AGENDA
CITY OF KENTWOOD PLANNING COMMISSION
TUESDAY, JUNE 28, 2022
KENTWOOD COMMISSION CHAMBERS
4900 BRETON AVENUE
7:00 P.M.

PROPOSED MINUTES OF THE REGULAR MEETING
OF THE KENTWOOD PLANNING COMMISSION
JUNE 14, 2022, 7:00 P.M.
COMMISSION CHAMBERS

Subject: Bretonfield Preserve Phase 6, Revised Tentative Preliminary Plat/Final PUD Site Plan

PRELIMINARY PLAT
BRETONFIELD PRESERVE PHASE 6
FOR: WESTVIEW CAPITAL, LLC
ATTN: DAN LARABEL
975 CLYDE COURT
BYRON CENTER, MI 49315
IN: PART OF THE S 1/2 OF SECTION 34, T6N, R11W,
CITY OF KENTWOOD, KENT COUNTY, MICHIGAN.

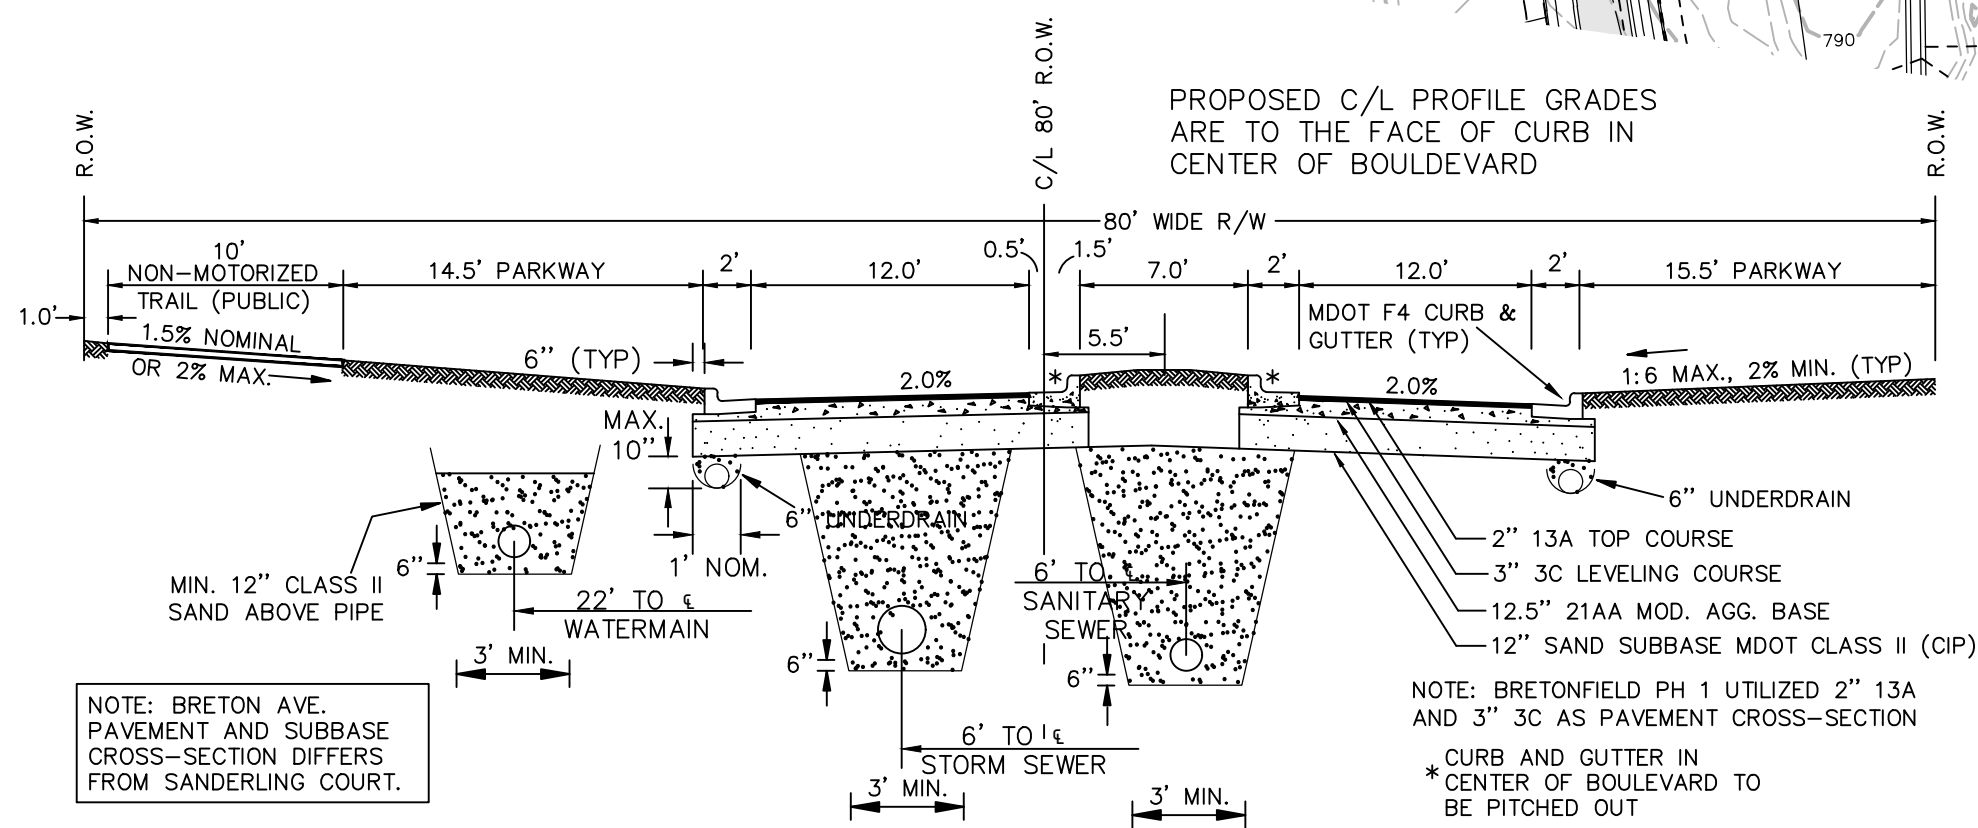
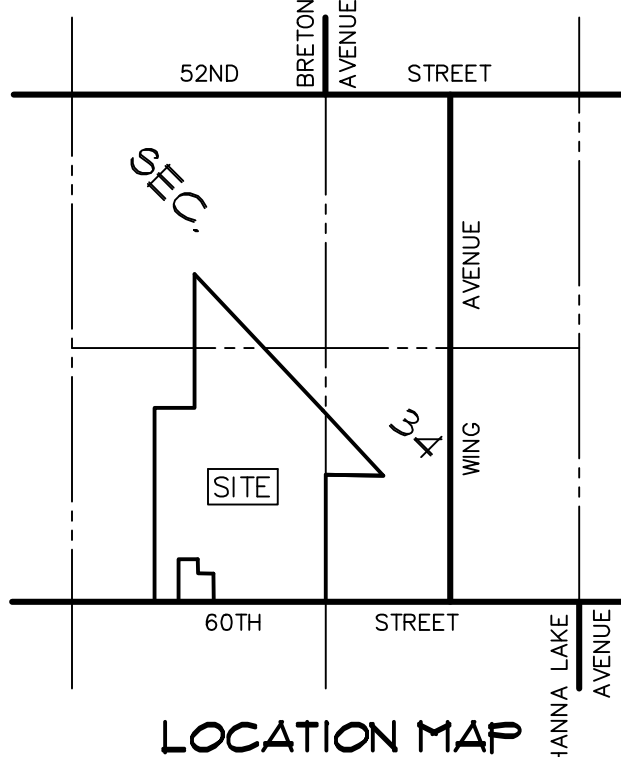
Pung stated as noted in the staff report, there were a few issues. He stated in the current plan they did not indicate any street trees on the east side of Breton Avenue. The trees will be added back in after discussion at the staff work session.

Pung stated there were also issues with regard to the design of the trail connection between Breton Avenue and the Paul Henry Thornapple trail. He stated the trail connection will be shown at a minimum width of 10 feet and there will be a note on the plan that final location and orientation would be determined when they work with City staff to figure out exactly where it is going to intersect with the Paul Henry trail and what the layout would be.

West stated regarding lots 208 and 226, the two lots on the west side of Breton, they spoke to the Engineer after meeting with staff and they think they can make an adjustment to the cul-de-sac and push it just a little bit west, modify some of the other property lines/lot lines to gain more width. West stated staff explained they want it a minimum of 20 feet off the Breton ROW. He stated they will get it to 20 feet from the Breton ROW on lots 208 and 226. He stated they will show that on the revised site plan.

West stated the dimensions of the pavilion will be 20x32. He will have the dimensions on the revised plan that they submit. He stated as far as the tot lot area that is approximately 54 x 58 feet. He stated he will get that on the revised plan as well.

- Street trees have been added along the East side of Breton Avenue.
- A total of 15 additional trees will also be installed within the open space area located along the East side of Breton Avenue, in addition to the existing trees that will be preserved in this area.

- The path connection has been revised to 10-feet wide with a 20-foot wide public easement. It is understood the final location of the path and related details will be discussed between the Developer and the City with submittal of the detailed engineering plans.

- Adjustments have been made to Sanderling Court and units located West of Breton Avenue to provide an additional 8-foot lot width for Units 208 and 226 (previously 52-wide, now 60-feet wide).
- Units 208 and 226 will now provide a minimum 15-foot East side setback (facing Breton Avenue) and a minimum 5-foot West side setback. Lot width adjustments are shown on the revised plan and the enhanced side yard setbacks are referenced in General Note 6.

- The proposed size of the pavilion (20' by 32') and tot lot (54' by 58') have been added to the plan.
- The pavilion will include picnic tables and the tot lot will include benches.
- The tot lot and pavilion area is situated approximately 75 feet from Breton Avenue with the entry point from the 10' path along the West side of Breton Avenue defined with a concrete sidewalk, decorative split rail fencing and landscaping.
- Given these design characteristics and the desire to maintain an open/natural setting for this community amenity, additional fencing is not considered desirable or necessary.
